# North Field Patchway Supplementary Environmental Information

**NORTH FIELD, FILTON**  
**Planning Application PT03/3143/0**

**ENVIRONMENTAL STATEMENT**  
**SUPPLEMENTARY ENVIRONMENTAL INFORMATION**

3 August 2007

Figure 3.1a: Land use

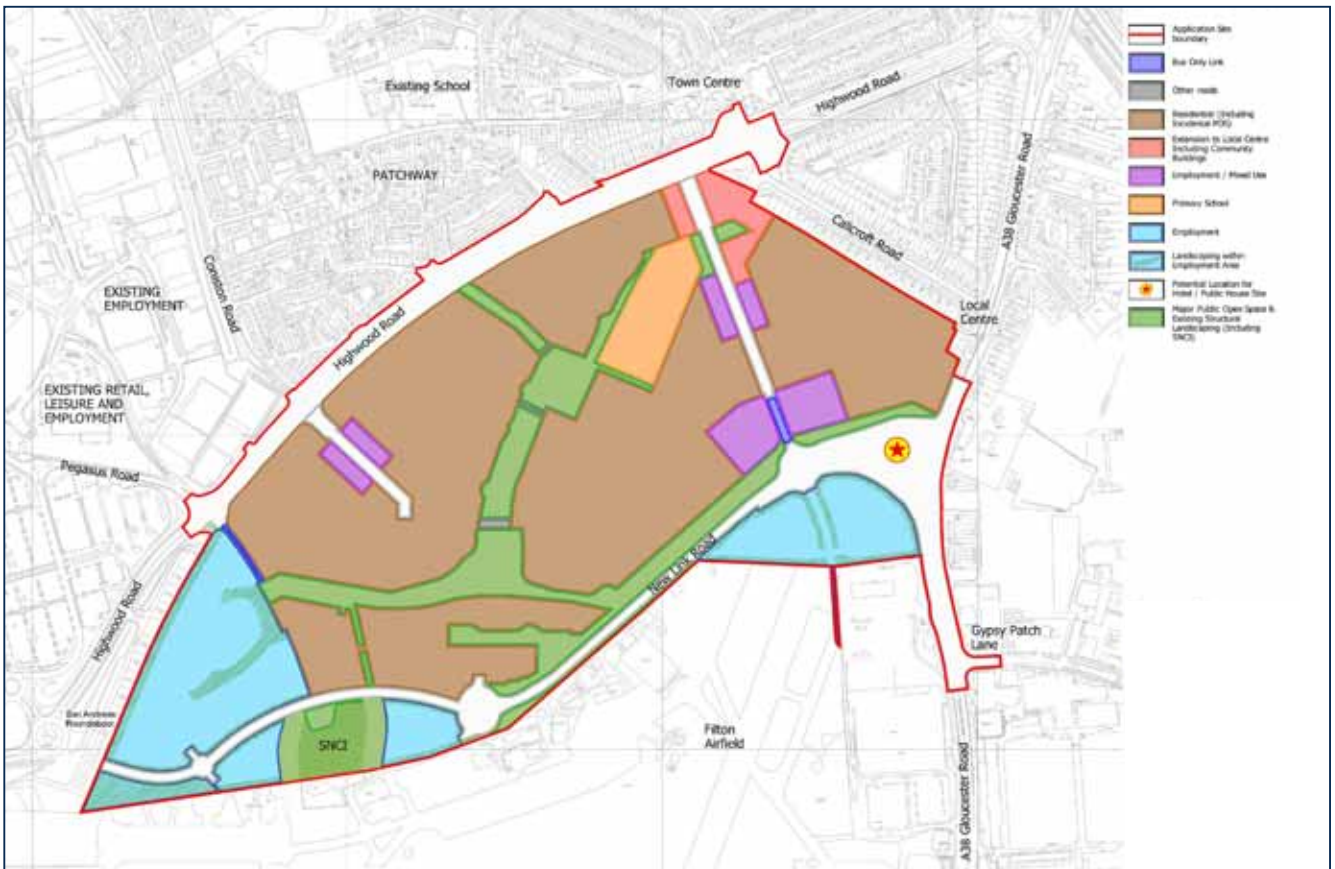
- 1.3 The plans that have been amended are:
- figure 3.1a land use plan, which shows the various land use components of the development, identifying the general land use arrangement

- 1.4 These plans have been amended to reflect the following key changes to the development proposals:
- allowing for revised link road alignment to connect the western end to the San Andreas roundabout option, which is the option preferred by South Gloucestershire Council

- revised public transport arrangements within the site boundary and alterations to primary access routes into the site to reduce segregation of routes as recommended by the Inspector's Report

- inclusion of areas of mixed employment / residential use to accommodate approximately 25% of the proposed employment floorspace
  - extension of the local centre

- amended open space and planting
  - alterations to the pedestrian / cycle routes, with more shown overall.
- 1.5 Despite these changes, the overall development rationale and key principles for North Field remains as set out in paragraph 3.16 of the ES.

- 2.10 Paragraph 3.54 of the ES, which refers to the link road alignment, is deleted. Paragraph 3.55 is replaced with the following paragraph.
- 2.11 The alignment of the link road between the A38 and the San Andreas roundabout with Highwood Road, as shown on figure 3.1a, has been agreed with South Gloucestershire Council.

Figure 3.1b: Building heights

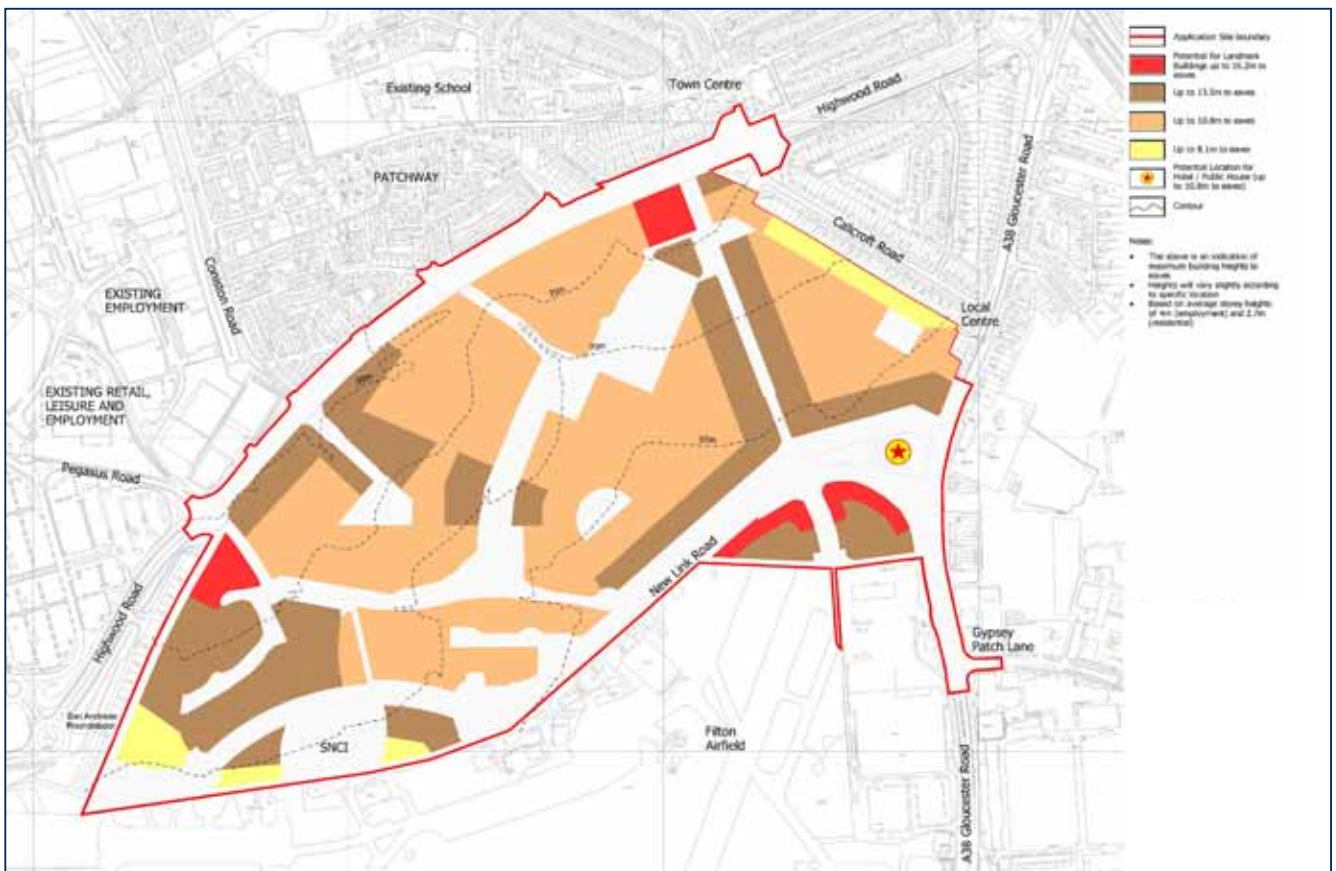
- figure 3.1b building heights plan, which shows intended restrictions over building heights, relating to the site's topography, airfield restrictions and urban design objectives

Figure 3.1d: Strategic landscape and open space

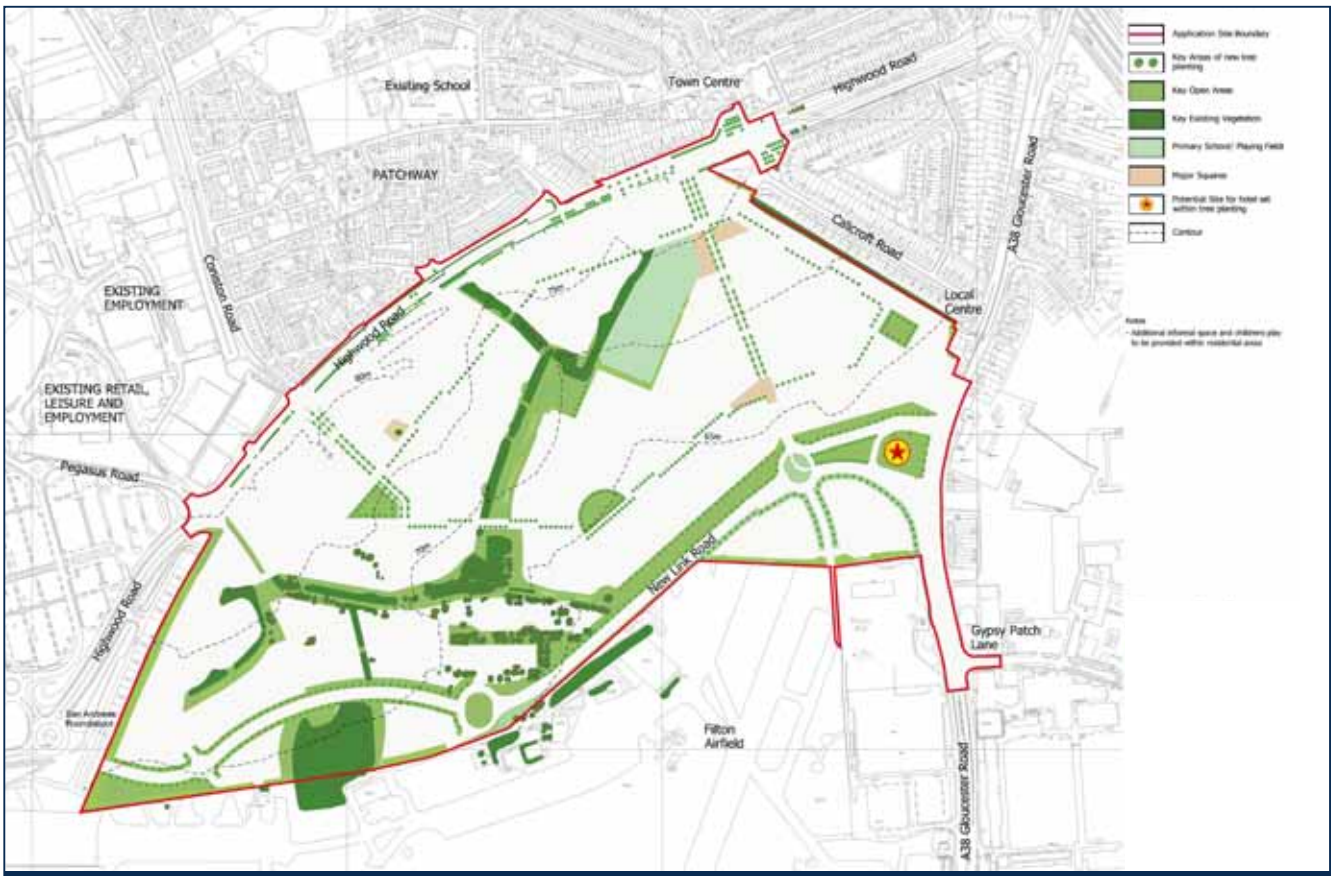
- figure 3.1c density plan, which links to the building heights strategy and shows how the density of development would vary throughout the site
  - figure 3.1d strategic landscape and open space plan, showing strategic planting and tree retention

- 2.9 The first sentence of paragraph 3.50 is revised to read as follows: the master plan provides in the region of 8.11 ha of major public open space and strategic landscape, excluding Filton Wood SSSI, together with incidental open space accommodating children's play areas.

Figure 3.1e: Access and movement

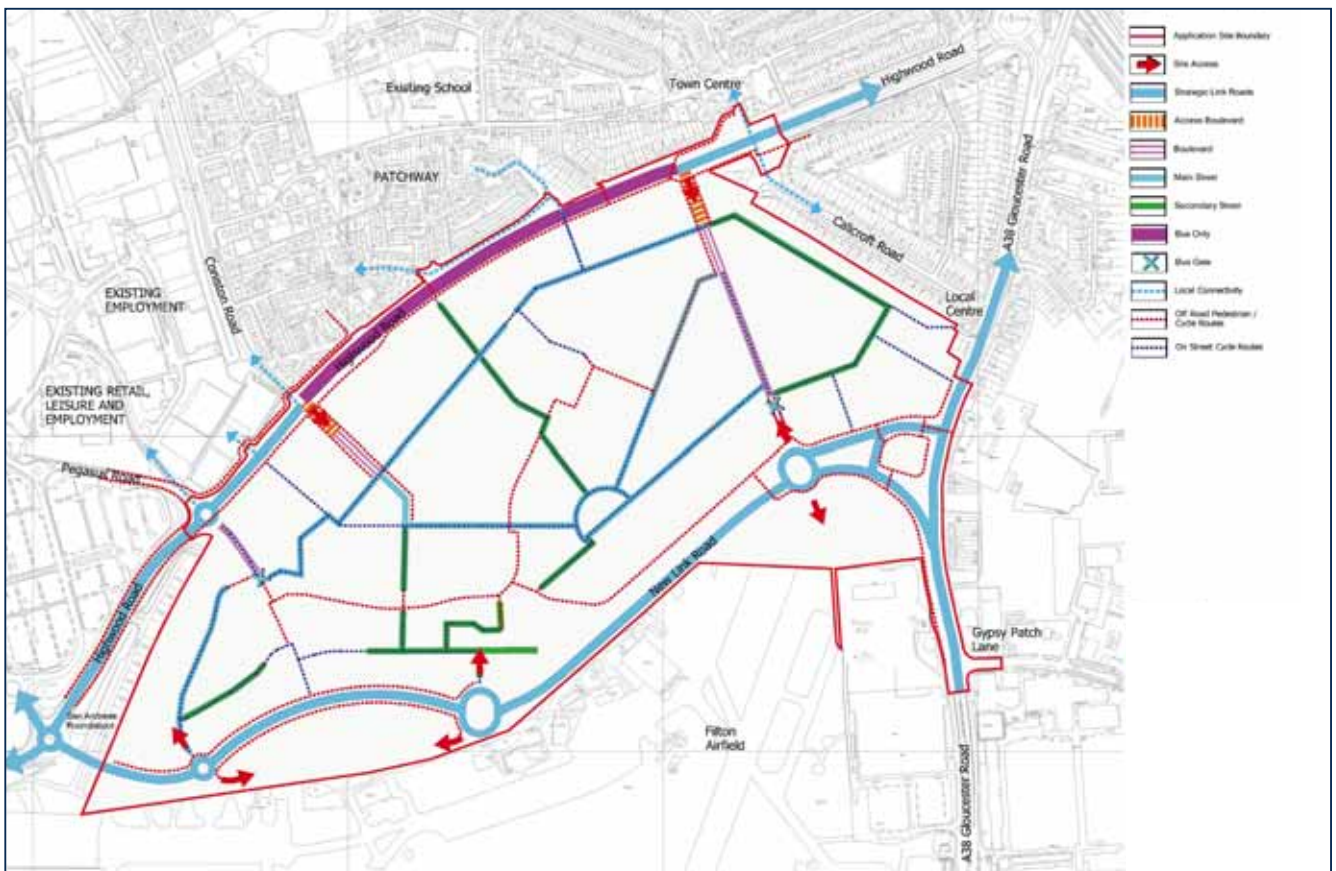
- figure 3.1e access and movement plan, showing the principal arrangement of vehicle, public transport, cycle and pedestrian links within the site
  - figure 3.1f phasing plan, which shows the general phases in which the development is expected to be implemented.

- 2.13 The first sentence of paragraph 3.63 is revised to state that the master plan and internal road network have been designed to accommodate dedicated bus links in order to facilitate a high frequency, quality service through the development area.
- 2.14 The phasing programme set out under paragraph 3.66 of the ES is replaced with the following text:

Figure 3.1f: Phasing

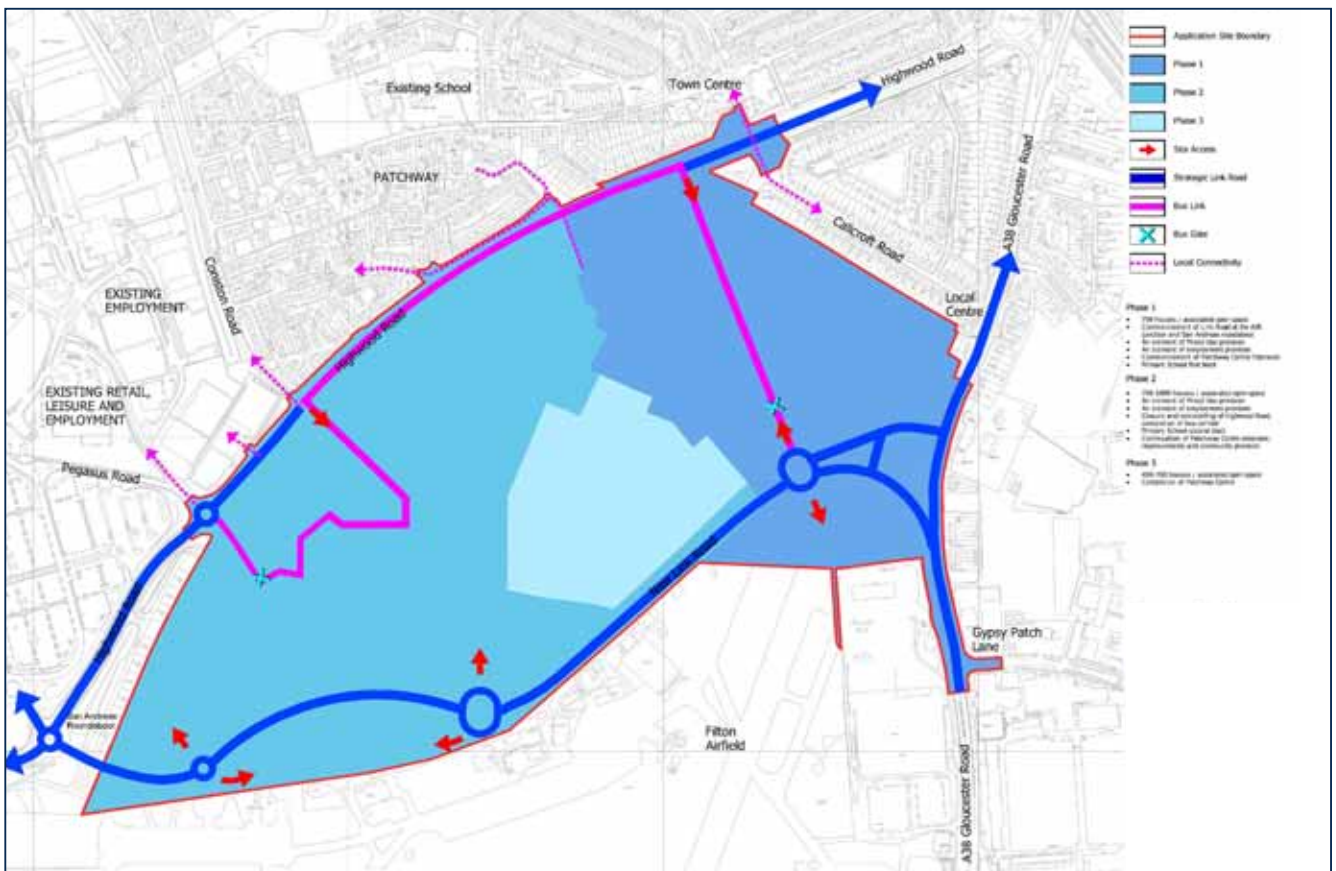
*Phase 1*

- 750 houses / associated open space
- commencement of the Link Road at the A38 junction and San Andreas roundabout
- an element of mixed use provision
- an element of employment provision
- commencement of Patchway Centre extension
- primary school first block

*Phase 2*

- 750-1,000 houses / associated open space
- an element of mixed use provision
- an element of employment provision
- closure and remodelling of Highwood Road, completion of bus corridor
- primary school second block
- continuation of Patchway Centre improvements and community provision

*Phase 3*

- 450-700 houses / associated open space
- completion of Patchway Centre

Figure 9.9: Vehicle access strategy

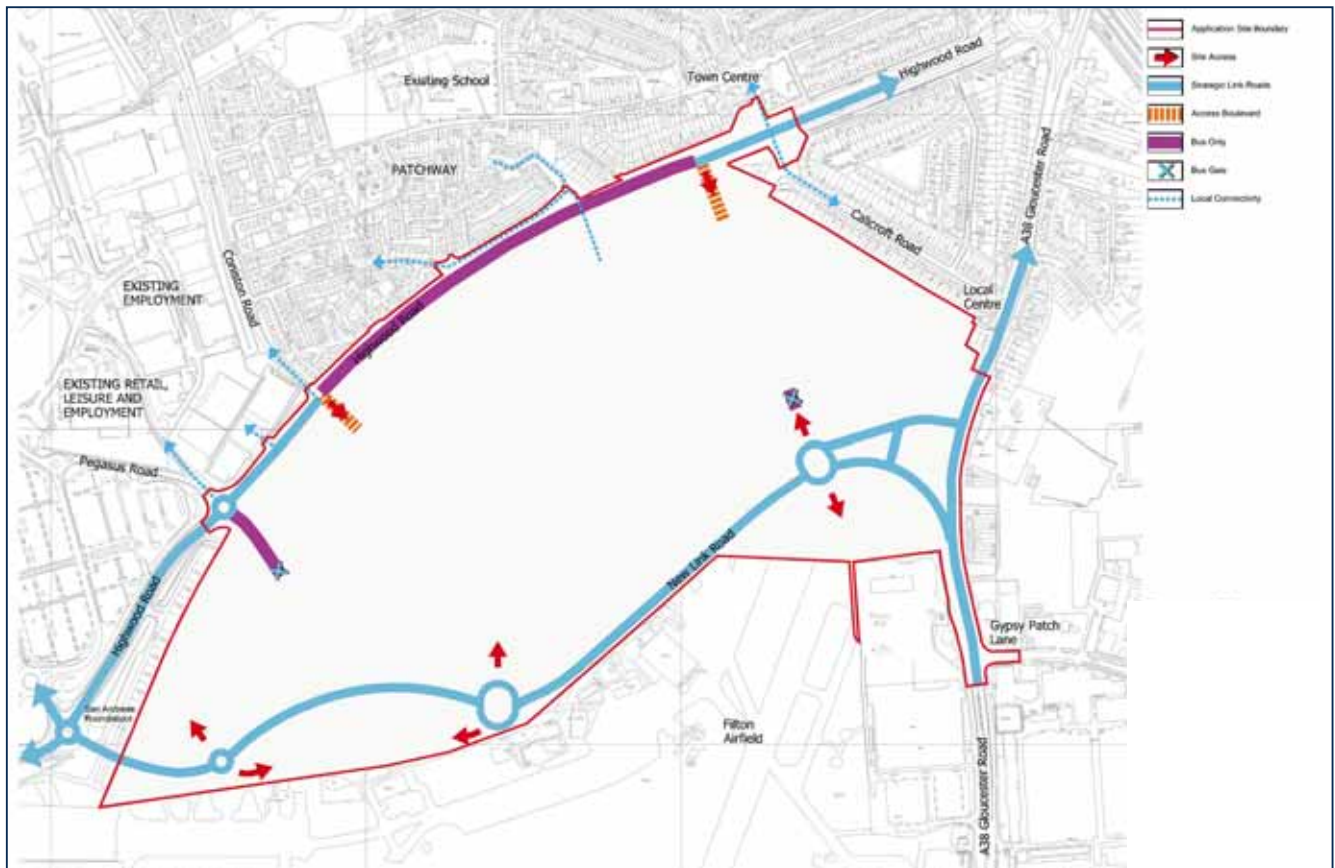
- 2.51 Figure 9.9 (vehicle access strategy) is updated to reflect the proposed changes to the link road alignment, public transport links and access arrangements, as shown on figure 3.1e. The last cell of figure 9.10 is revised to refer to the San Andreas roundabout in the AM peak.
